ADDENDUM 1

Project: REVISED Saline Middle School Solar-Integrated Roof

ROOF DECK PLAN

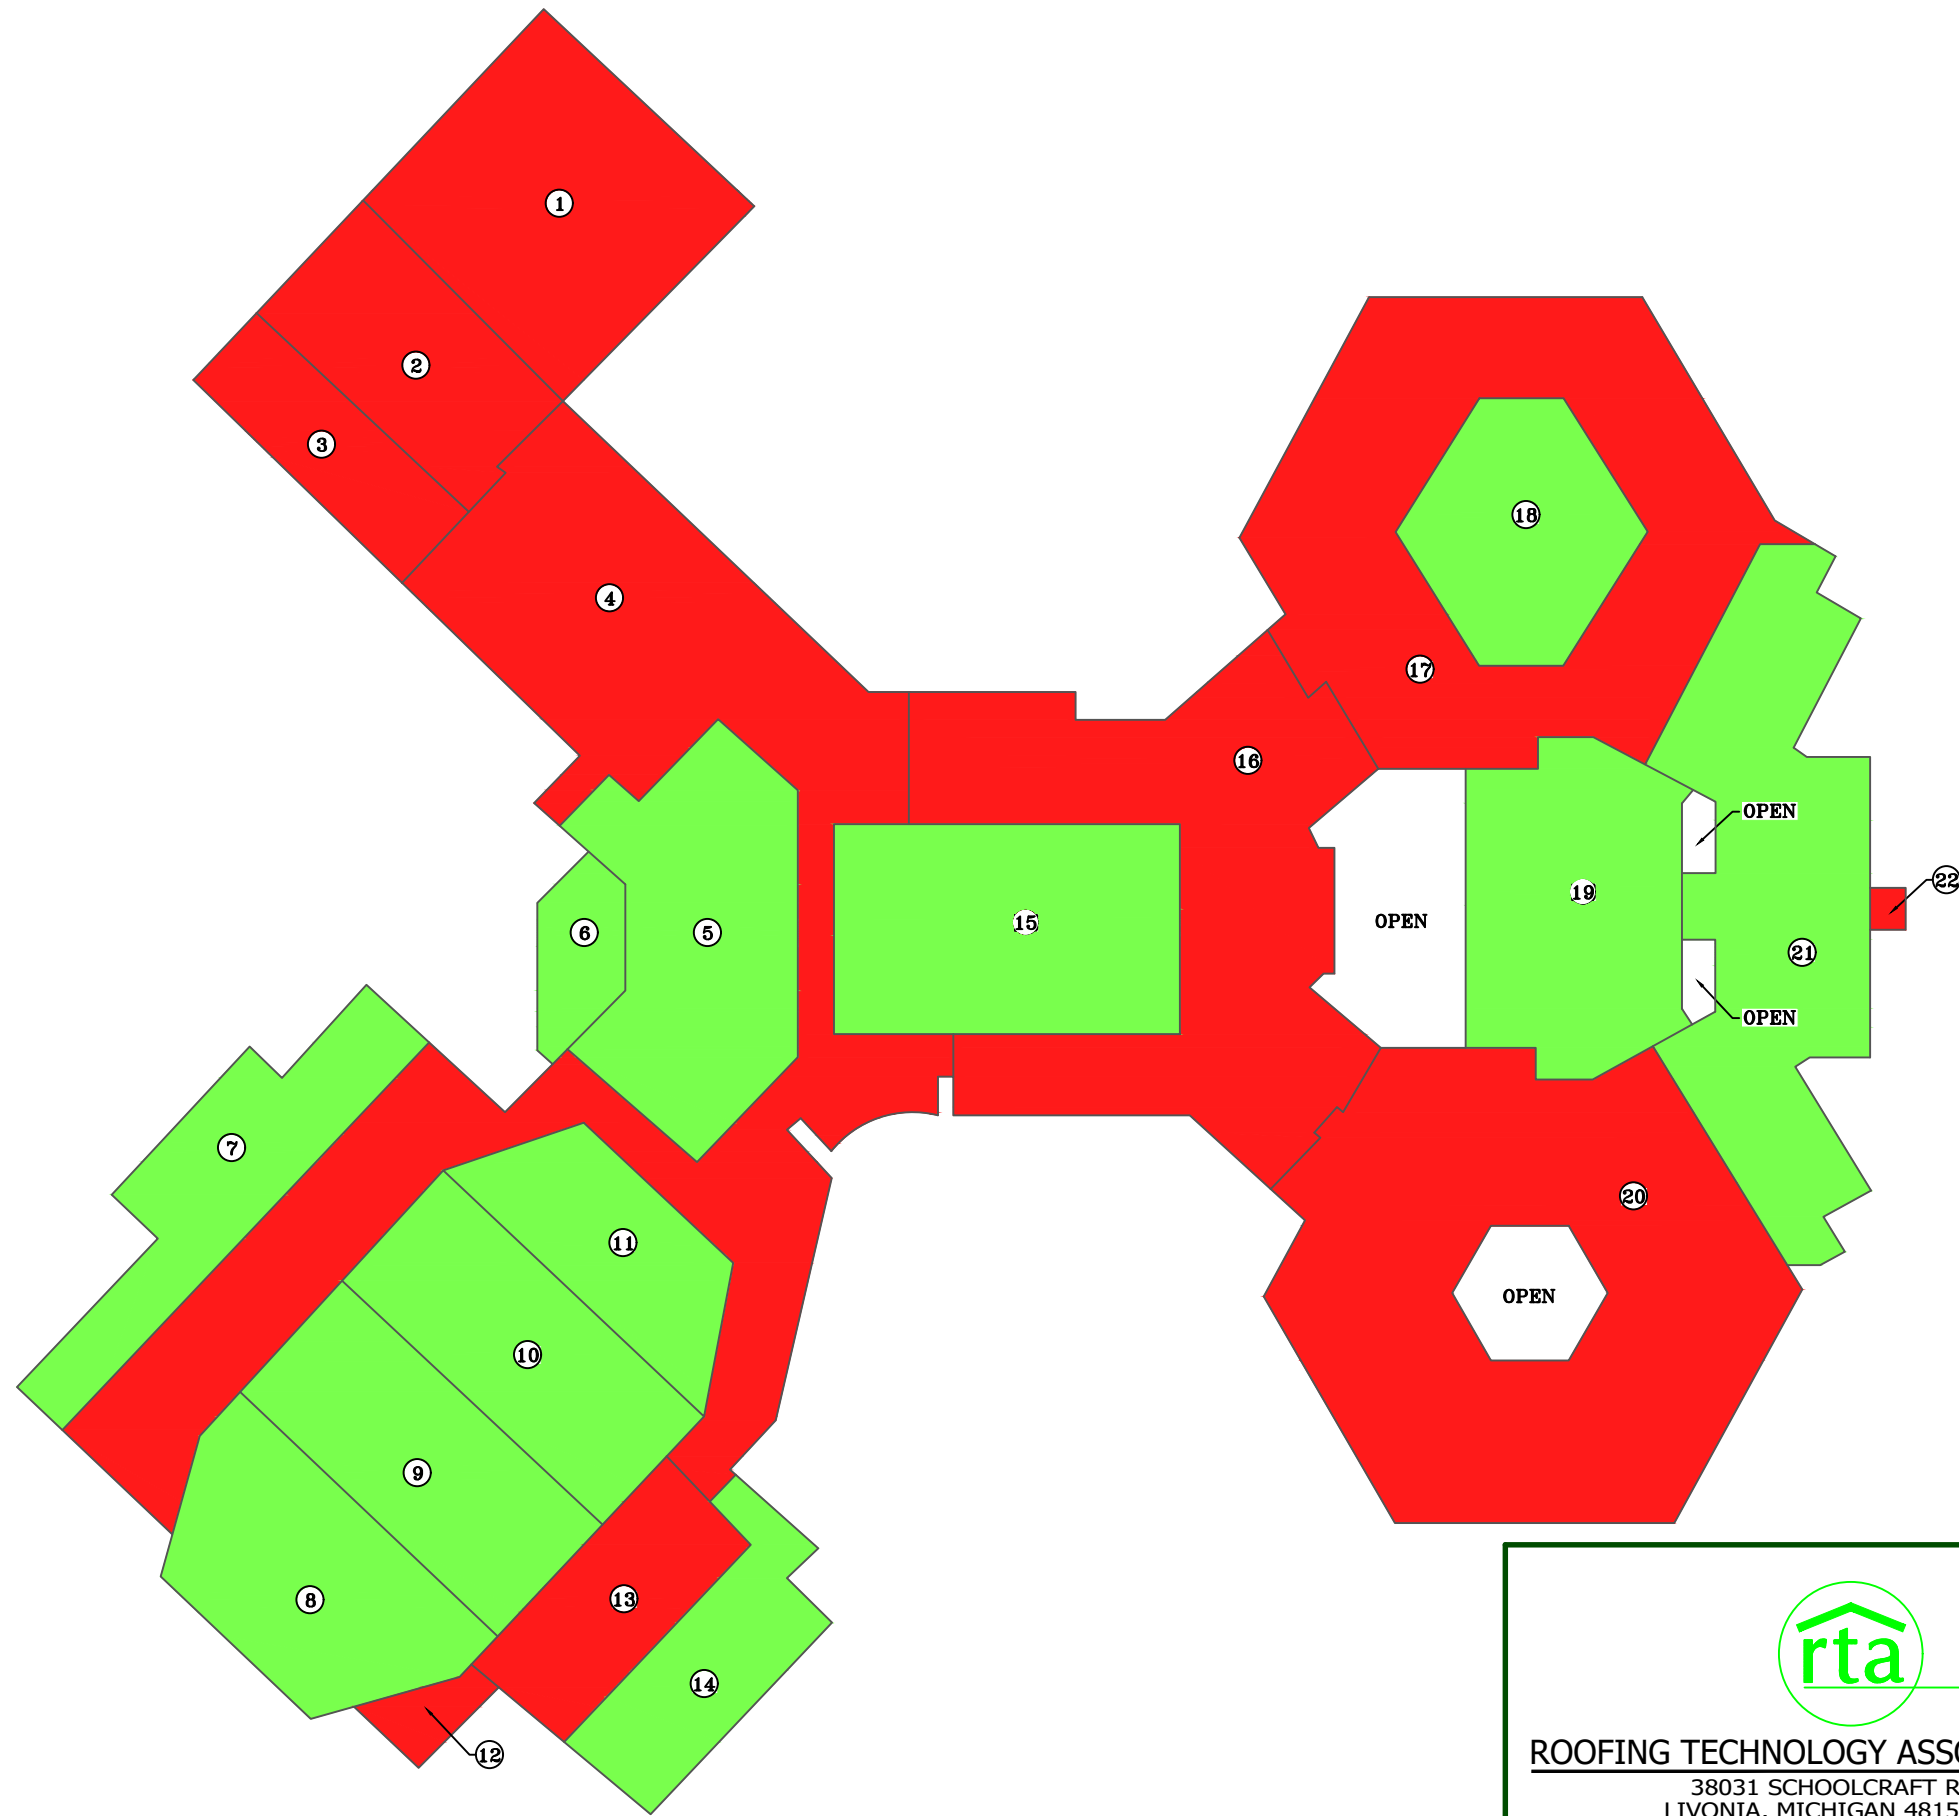
- 3Q. Can you provide a drawing showing the deck construction between gypsum and metal?
- 3A. Attached to this addendum is a drawing showing this information.
